**Sparton Corporation
Coors Road Facility**

**B&V Project 26602.0100
B&V File B
May 29, 1996**

**Re: NMED Letter of May 22, 1996 (Facsimile)
Additional Monitoring Well Installation
Sparton Technology, Inc., Coors Road Facility
Albuquerque, New Mexico**

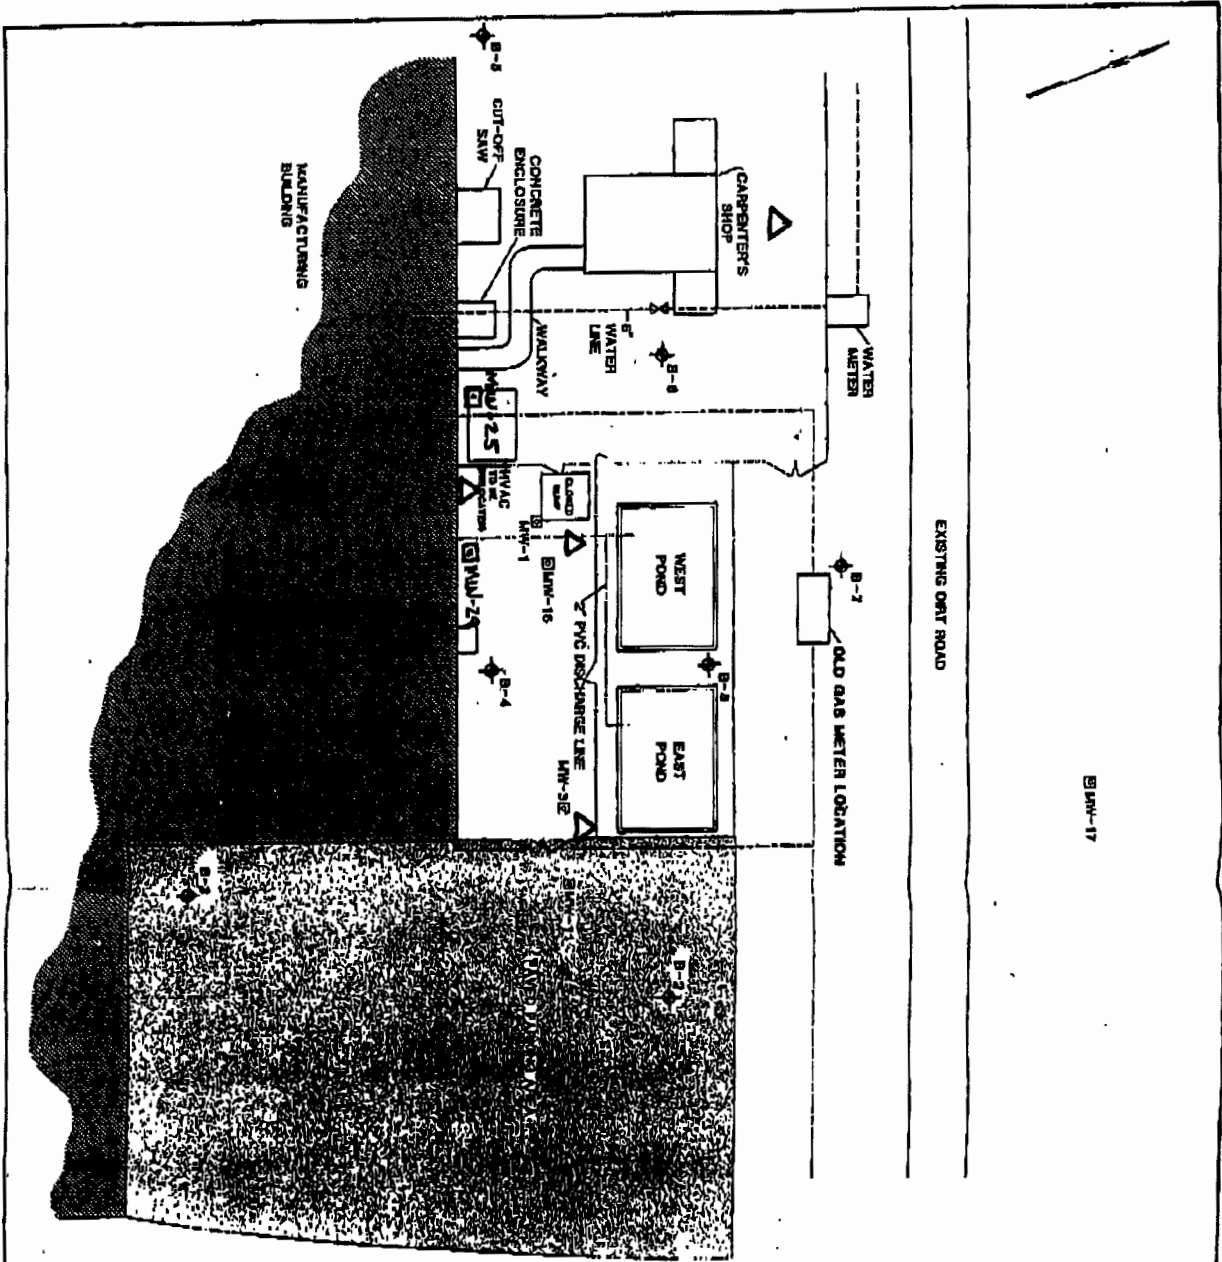
and reported to NMED and EPA. Soil and soil gas testing included PID (headspace) screening, total organic halogen (TOX), total metals, EP-tox, VOC indicators, and complete VOC Scan. A summary of results is given in the attached Table 2. A location map of borings/wells (RFI Attachment 6) is also attached. Approximate NMED nested vapor probe locations are also shown.

Based on the wealth of historical data, Sparton believes the source area has been well characterized and that a single nested vapor probe should be a cost-effective way to demonstrate/update current soil gas conditions in the source area.
